**Decision Record**

Individual Environmental Report Supplemental #7  
LAKE PONTCHARTRAIN AND VICINITY,  
NEW ORLEANS EAST LAKEFRONT TO MICHOU D CANAL  
ORLEANS PARISH, LOUISIANA

IER #7

Figure 3. Construction plan view of the temporary traffic control bridge and detail for placement of H-piles.

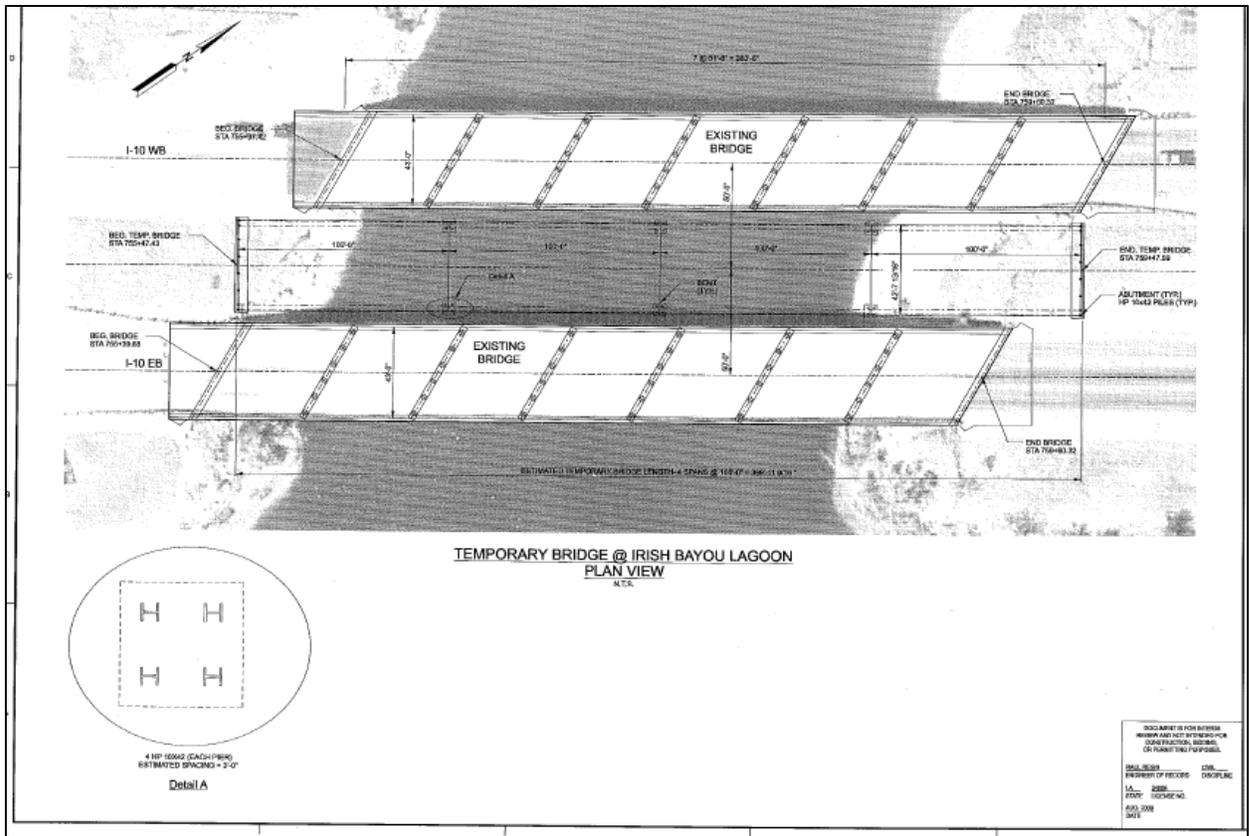
The temporary bridge across Irish Bayou would be approximately 400 feet long, and consist of four 100 foot spans, supported on 2 bents per span with 4 steel piles each. The bridge would be approximately 43 feet wide and transition to the temporary roadway surface with 2 abutments each supported on 8 steel piles at the bank line (figure 3). The existing riprap along the bank of Irish Bayou and natural ground at the abutments would be cleared of vegetation and approximately 700 cubic yards of fill would be used to bring the natural ground surface up to the required temporary roadway surface. All work would take place within existing LADOTD Right-of-Way (ROW).

It is anticipated that the abutments would be constructed first. The first bents would be constructed from the bank and the first span would be put in place. Other span and supports would be built using the previous spans as a working surface. The temporary bridge would be required for approximately 18 months. The contractor would be required to deconstruct the temporary bridge and return the affected site back to its pre-construction condition at the end of the construction. Equipment used will include but not limited to: bulldozers, compactors, dump trucks, concrete mixers, cranes and pile driving equipment.

Figure 4: I-10 ramp expanded footprint

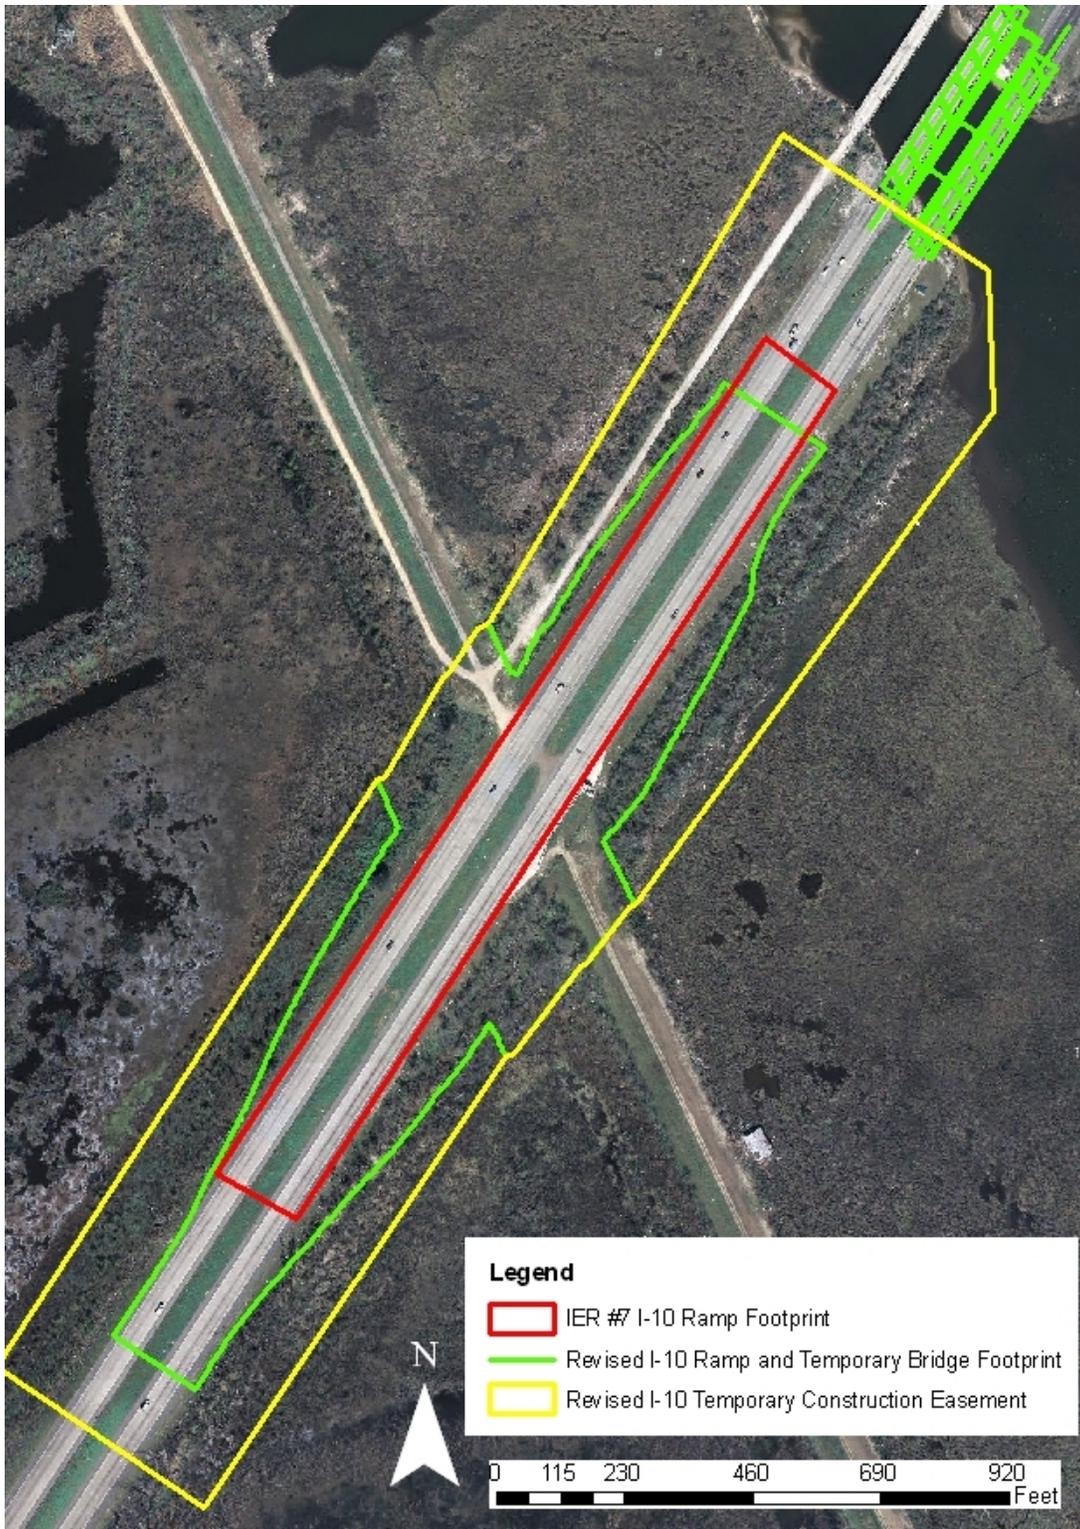
IER 7 provided limits of work for the I-10 crossing. The proposed action includes expansion of these limits (figure 4). The required footprint for the earthen ramp would be widened by approximately 50-100 feet on each side of the highway, and a temporary construction easement is needed between the new earthen ramp toe and the limits of the LADOTD ROW.

Figure 5: Highway 90 expansion

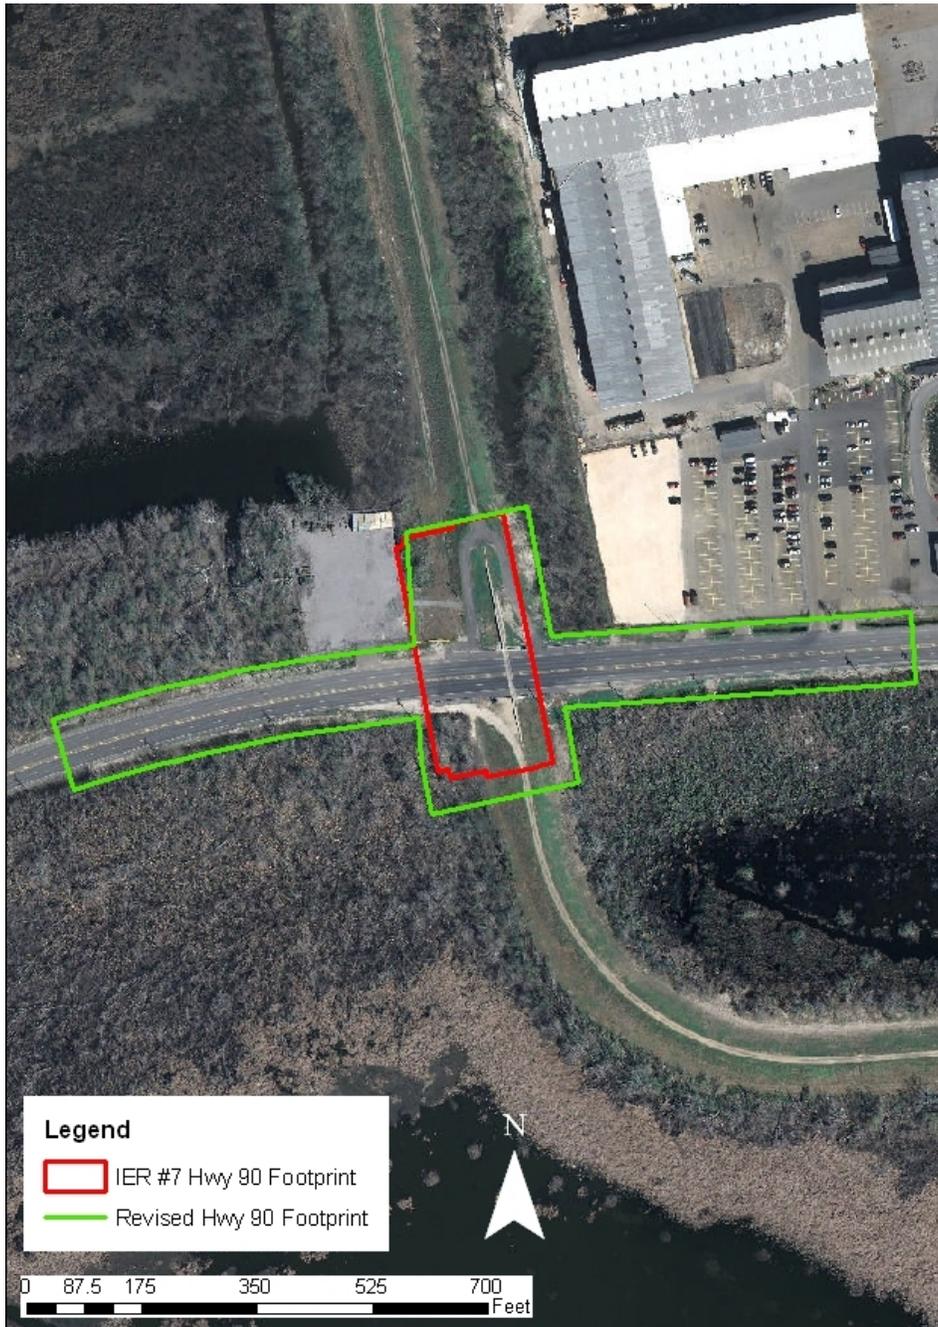
IER 7 provided limits of work for reach LPV 109.02c (US-90 Highway Crossing). The proposed action includes slightly expanded limits of work along the highway. For the new gate at US-90, the highway requires widening of approximately 25 feet on either side of the highway near the new gate to accommodate a safe distance buffer around the gate center post (figure 5).

Figure 8: LPV 111 barge offload sites

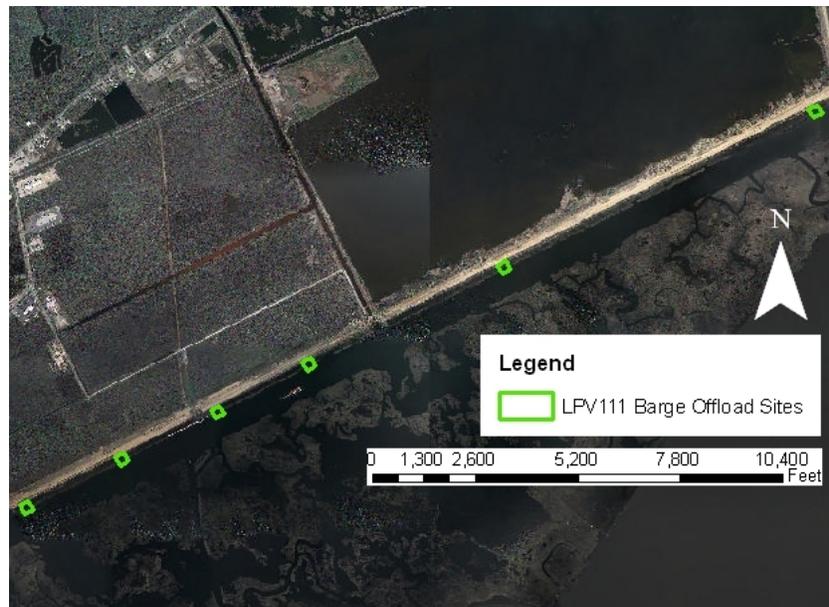
IER 7 anticipated delivery of cement to the LPV 111 reach by barge; however, it was anticipated that the cement delivered by barge would be pumped from barges in the Gulf Intracoastal Waterway (GIWW) across the wetlands so that no wetlands would be disturbed during the delivery. It is now anticipated that borrow material would also be delivered to the LPV 109 reach via barge along the LPV 111 reach. However, because clay material cannot be pumped, barge offload sites must be used. In cooperation with National Marine Fisheries Service, USFWS and Bayou Sauvage National Wildlife Refuge, six eroding access sites were identified for barge offload sites which minimize the impacts to marsh in this area (figure 8).

Figure 9: Conceptual barge offload site design

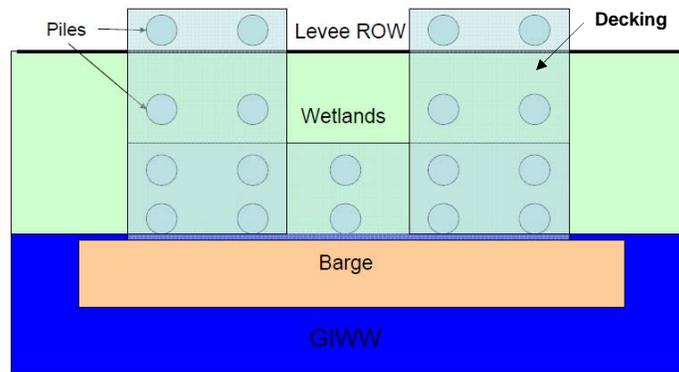
The barge offload sites would be designed to minimize impacts to the floodside wetlands along the GIWW. At each site, decking would be supported by approximately 18 piles at a height that allows adequate light to reach the marsh under the decking (figure 9). Flat top deck barges would be temporarily docked just off the marsh, and borrow would be moved via bulldozer, track hoe or similar machinery from delivery barges adjacent to the deck barges or the deck barge itself, across the decking, to trucks within the LPV 111 Levee ROW. These sites would be no larger than 250 feet wide, and would span the area from the levee ROW to the GIWW. After the delivery of all clay material is complete and these offload sites are no longer needed, the contractor will be required to remove the piles, barge and decking.

Figure 10: Typical LPV 111 T-wall cross-section

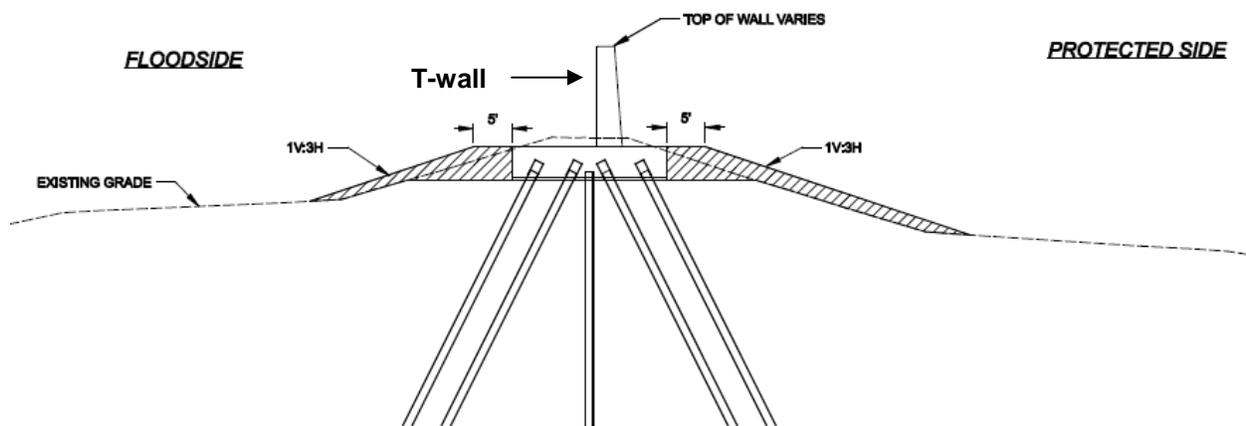
The selected plan for LPV 111 in IER 7 was a deep-soil mixed (DSM) levee. Although DSM has been selected as the preferred alternative for LPV 111, the schedule and budget for this action are largely based on validation of several variables, such as production rates of the specialized DSM machines proposed in the levee design. The validation phase is ongoing, in which these unknowns will be tested and field verified.

In the event that results of the validation phase prove that schedule cannot be met and cost becomes prohibitive, portions of the LPV 111 reach could be constructed as T-wall to accelerate the construction schedule and reduce cost. No more than 25% of the approximately 28,069 linear feet of this reach would be built as T-wall. The footprint for this T-wall would be no wider than the corridor needed for the DSM portions of the reach (figure 10).

Figure 11: Temporary pumping system for LPV 109 and LPV 111 USFWS Pump Stations

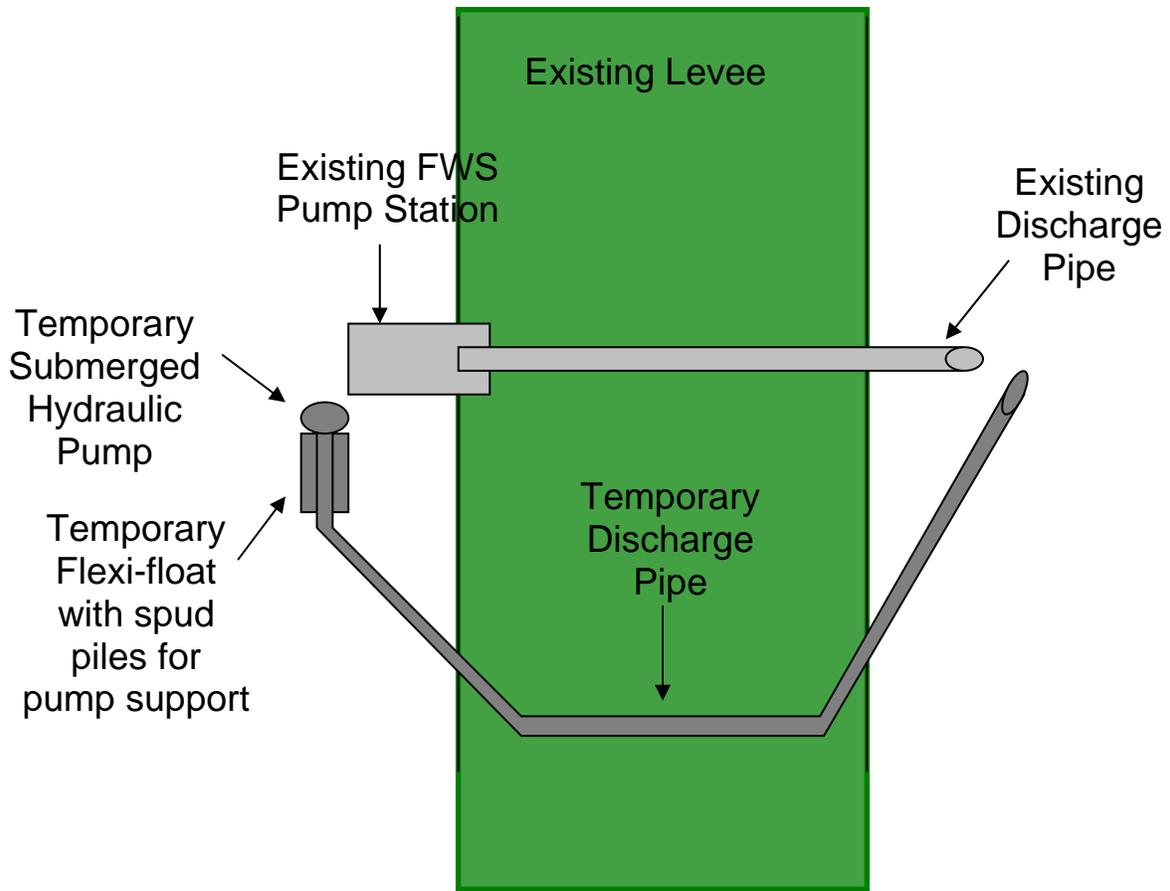
IER 7 described that the LPV 109 levee center line would be shifted to the protected side as much as 61 feet. Because of this shift in the centerline and raising the LPV 109 and LPV 111 levee to the 100 year elevation, modifications to the two existing USFWS pump stations located along the LPV 109 and one station located along the LPV 111 levee are necessary to maintain pumping capacity with raising the discharge pipe over new levee elevation. These proposed modifications include the following: raising and relocating the pump stations; replacement of the pump, gear, engine, formed suction intake, control panels, and 36" discharge pipe and appurtenances; installation of temporary cofferdams at the intake and discharge sites; installation of temporary piers, platforms and pumps during construction; and limited excavation within the existing right-of-way. Minor structural modifications may be needed depending upon the loading requirements for the new equipment, relocation of the access bridge, and removal and replacement of the chain link fence.

During the raising and relocation of these pump stations, temporary pumps would be provided to ensure current pump capacity is maintained during construction (figure 11). Two possible layouts are proposed for the temporary pump and discharge. Figure 11 shows one conceptual layout; the second possible layout would be similar to that shown in figure 11 but would be located on the other side of the existing station.

The discharge line would be routed around the section of levee in front of the station which would be temporarily degraded to approximately El. 5.0 to install the soil-cement elements. The discharge would be at the same location as the existing discharge. The temporary discharge pipe would be supported by a small, spud-anchored floating barge.

To install, access, and operate the temporary pumping system, it is necessary to acquire temporary construction easement so that the Contractor can position a crane with sufficient reach to install the floating barge, and pump and drive the barge's spud piles. To support the weight of this crane, it is likely that a working platform with several feet of rock would need to be placed in one of the additional easements, and the crane matted to further spread the load out. These construction easements would be adjacent to the existing pump station and discharge pipe. Once the relocated pump stations are operational, all temporary features will be removed.
